URGENT MEDICAL DEVICE CORRECTION URGENT FIELD SAFETY NOTICE

Subject:	X-Jaw Carrier Replacement
Commercial Name of Affected Product:	Clinac, Trilogy, Novalis Tx, Unique
Affected Version(s) / Lot(s):	Not applicable.
Reference / FSCA Identifier:	CP-08881
Date of Notification:	2012-08-14
Type of Action:	Notification and Correction
Details on Affected Devices:	Refer to appendix page.

Figure 1. On the left picture, the X-jaws with the jaw carriers noted with the red arrows. On the right picture, the red arrow shows the point of failure on the jaw carrier.

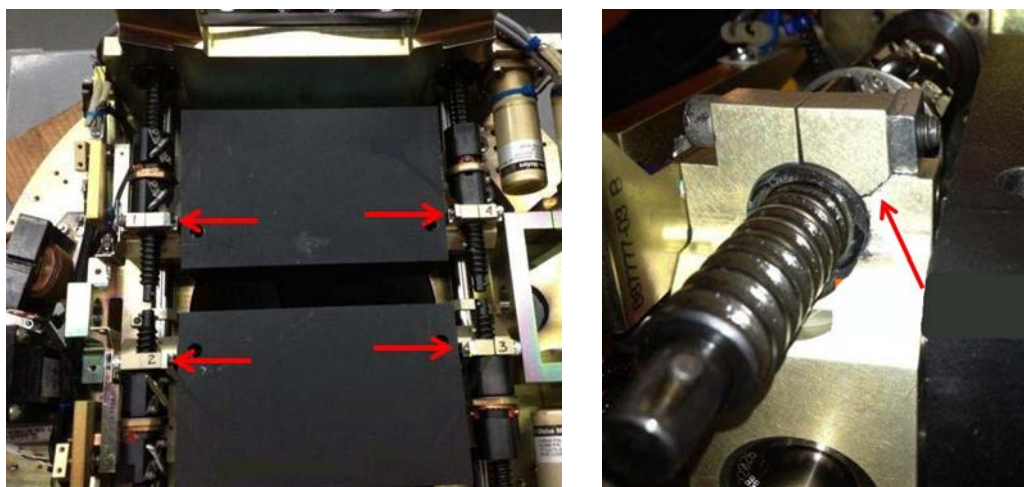
This letter is to advise you of an anomaly that has been identified with the Clinac, Trilogy, Novalis Tx and Unique jaw carriers. The jaw carriers function to couple the X-jaws to their respective drive screw mechanisms used for controlling field size (refer to Figure 1). Some jaw carriers were manufactured with the incorrect metal alloy, which can potentially cause the jaw carrier to crack.

If both jaw carriers on the same X-jaw were to crack, the jaw would be able to move freely in the closed direction. In this case, the deviation of the jaw position will not be detected by the position readout interlock circuitry. Treatment after such a failure occurs may lead to an under-dose of the intended target volume. This condition was found on some machines. No patient mistreatments were reported to Varian Medical Systems.

- Immediately contact your Varian local service organization when abnormal noises are observed in the collimator head while rotating the Gantry or Collimator.
- Verify the jaw position prior to the treatment of every field. This is typically done using portal imaging or field light projection.

- Varian Medical Systems is notifying all possibly affected customers with this document.
- A Varian Medical Systems Customer Support Service representative will schedule a visit to inspect and replace the jaw carriers on your system as necessary.
